RE: Request for Additional Information
Wayland Town Office Discharge Site
Transmittal No. X250635

Town Office Building Groundwater Discharge

41 Cochituate Road

FIGURE 4-3R2

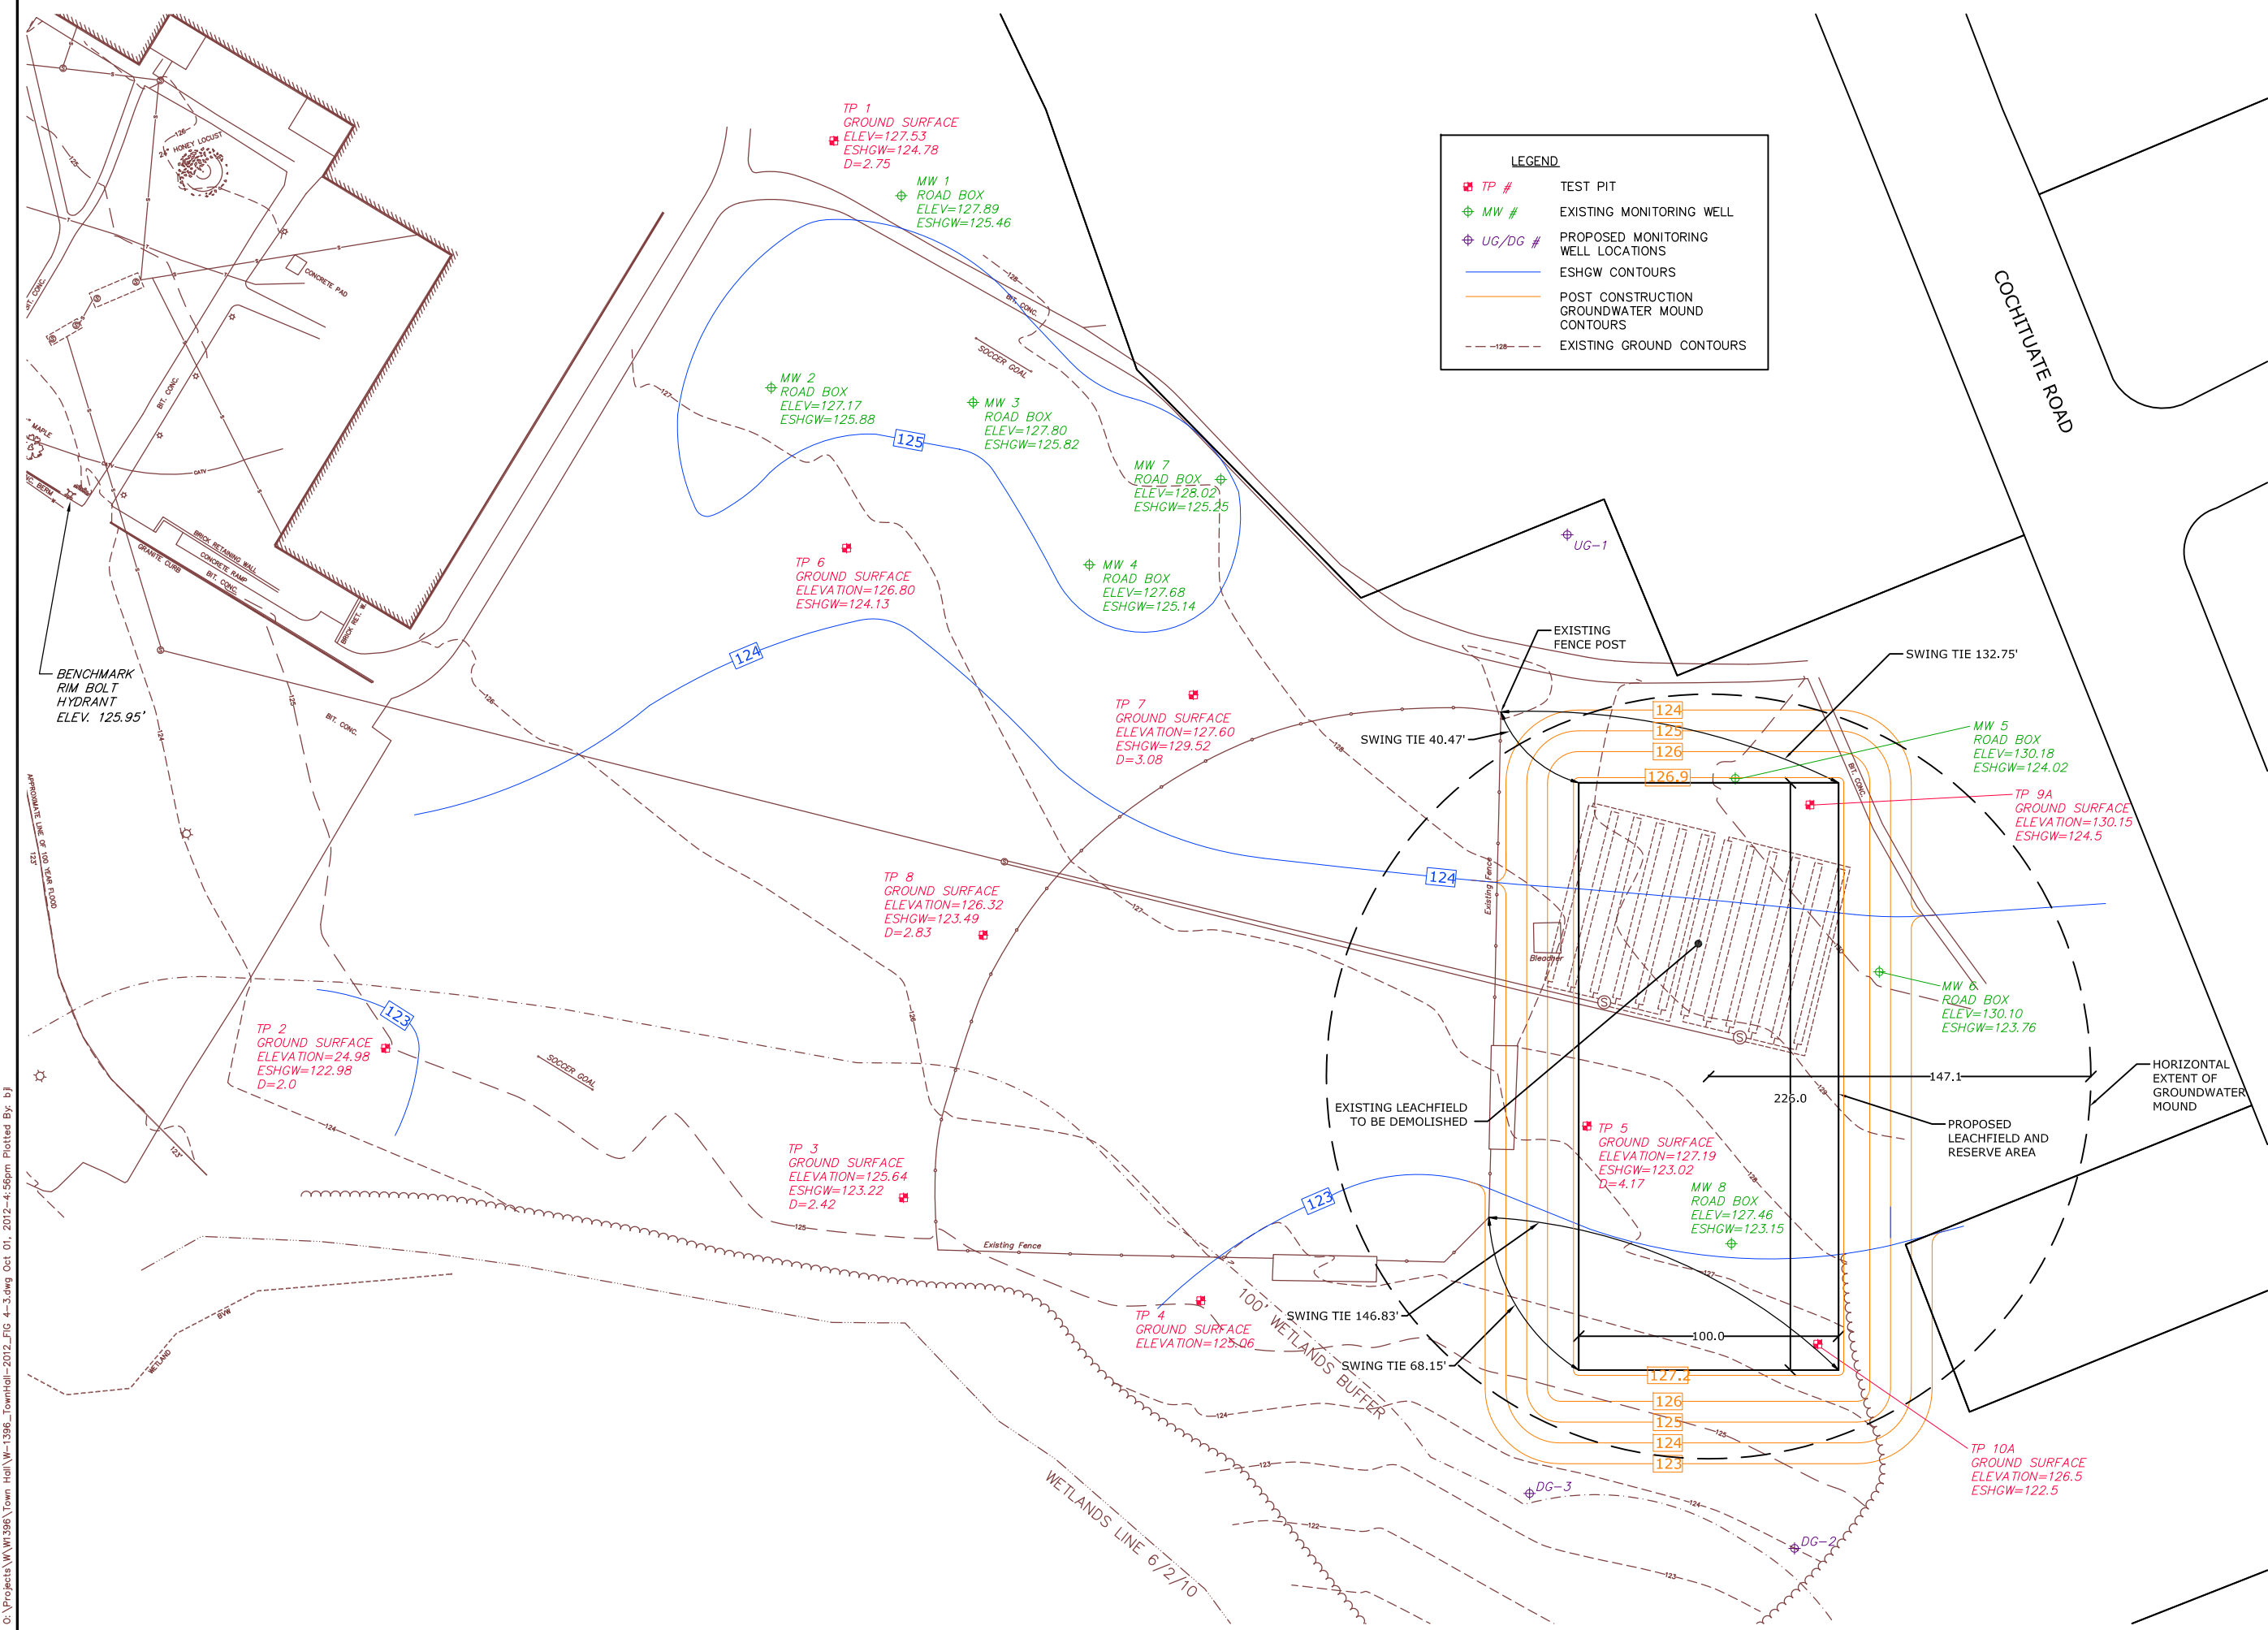
- We concur that the mounding analysis method employed is acceptable to MassDEP, however we noticed that several of the input aquifer parameters employed in the most recent mounding analysis differ from the values determined in the initial hydrogeologic report; specifically hydraulic conductivity was initially determined to be 76 feet/day and a value of 0.12 was assigned to specific yield. These values in the latest mounding analysis have been revised to 57 feet/day and 0.24 respectively. While these changes do not significantly alter the results of the mounding analysis, what is the rationale behind the change?

Regarding the hydraulic conductivity, this number was decreased from 76 feet/day to 57 feet/day based on the incorporation of the percolation test results. Based on our discussions, we understand that this is not a MassDEP accepted practice, even though it has been used on other MassDEP approved projects. In response to your comment, the data point associated with the percolation test has been eliminated and the hydraulic conductivity value was recalculated to the original value of 76 feet/day.

Based on this, all calculations submitted under this response are based on a specific yield of 0.24 ft³/ft³ and a hydraulic conductivity (K) of 76 feet/day. The groundwater mounding analysis was updated to reflect these changes. As a result, the projected groundwater mound height is 2.4 feet, approximately 0.3 feet less than submitted under the letter response. The corresponding elevations and grading have been updated to reflect this change. Attached to this letter are the following figures:

- *Figure 4-2R2 – Geologic Cross-Sections, Updated October 2012*
- *Figure 4-3R2 – Groundwater Contour Plan, Updated October 2012*
- *Figure 5-1R2 – Effluent Disposal Layout, Updated October 2012*
- *Figure 5-2R2 – Disposal Bed Profile, Updated October 2012*

Septic System Analysis

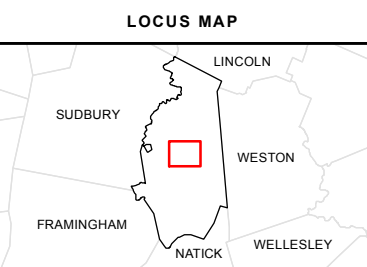
Given the site's shallow depth to groundwater, relatively flat water table (hydraulic gradient of approximately 0.005 ft/ft) and close proximity to abutters north of the proposed discharge, MassDEP requests that T&B reassess how abutting foundations, basements and septic systems will be impacted by the proposed discharge. MassDEP recommends that T&B contact the Wayland Board of Health to obtain all available information regarding the location and construction of septic systems, depths to groundwater and history of wet or flooded basements for all abutting properties located north and east of the proposed discharge location. T&B must adequately evaluate and assess potential hydraulic impacts to abutting sensitive receptors before a site approval letter can be issued by MassDEP.

Tighe & Bond agrees that using the Bouwer method for square or irregular shaped basins is an appropriate method for the SAS layout in Wayland. Using the revised hydraulic conductivity (K) value of 76 feet/day and an H_c feet (height of groundwater mound in center of recharge area) value of 2.4, with all other parameters the same, this results in a L_n (distance from the center of recharge area and control area) of 147.1 feet. This is the revised estimated extent of the groundwater mound from the center of the recharge area. This revised horizontal extent has been updated in all of the attached figures previously mentioned. In addition, an additional figure called Septic System Analysis has been appended to this letter to show the proposed SAS in relation to the neighboring septic systems. A circle has been drawn to show the horizontal extents of the proposed SAS, and as you will see in the figure, an emergent groundwater problem is not anticipated as there are no basements or septic systems within the horizontal extent of the groundwater mound. For your reference, the documentation obtained from the Wayland Board of Health that was used to develop this figure and locate the existing septic systems in the area has also been appended to this document.
